Application No.: 10/751,218
Amendments dated July 28, 2005
Response

Amendments to the Drawings

The appended sheet of drawings displaying 2 figures, i.e., figures 2 and 4, labeled “Replacement Sheet” follows and supplants or replaces the appended sheet of drawings labeled “Annotated Marked-up Drawings,” the second of seventeen sheets of drawings submitted with “Wake Tower and Method of Making Same,” Serial Number 10/751,218, Docket No. 002-54A that displays figures 2 and 4.

FIG. 2

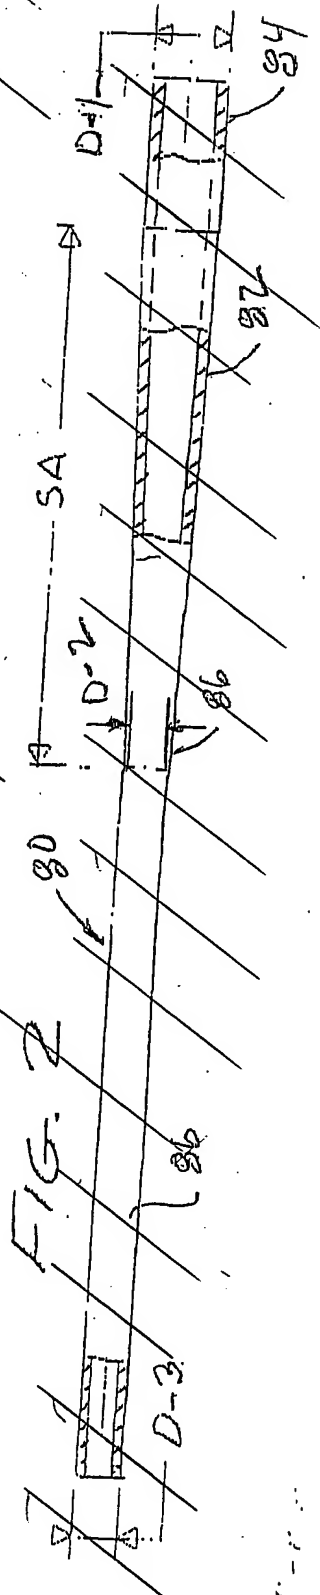
Secondly, the Examiner points out that "first and second ends #80a-b, as mentioned on page 11, line 5 ..." are not included on the drawings. Elements 80 and 80b **omitted from** figure 2 of the "Annotated Marked-Up Drawings" sheet are **added to** figure 2 of the "Replacement Sheet" appended.

The figure 2 drawing given in the "Annotated Marked-Up Drawings" sheet appended is also objected to for failing to comply with 37 CFR 1.84(p)(4) for having "86" "used to designate two different parts in Figure 2". Applicant's attorney wishes to take this opportunity to thank the Examiner for his pointing out this oversight, and figure 2 of the "Replacement Sheet" has been amended to distinguish element 86a from element 86; see above Amendments to the Drawings.

Figure 2 of the appended “Annotated Marked-up Drawings” sheet **is replaced by** figure 2 of the “Replacement Sheet” of drawings. Elements 80a and 80b, **omitted from** figure 2 of the “Annotated Marked-up Drawings,” are **added in** figure 2 of the second “Replacement Sheet” of drawings including figure 2. And element 86a omitted from the 2nd “Annotated Marked-up Drawings” sheet is **added** to the “Replacement Sheet” of drawings distinguishing it from element 86 of figure 2.
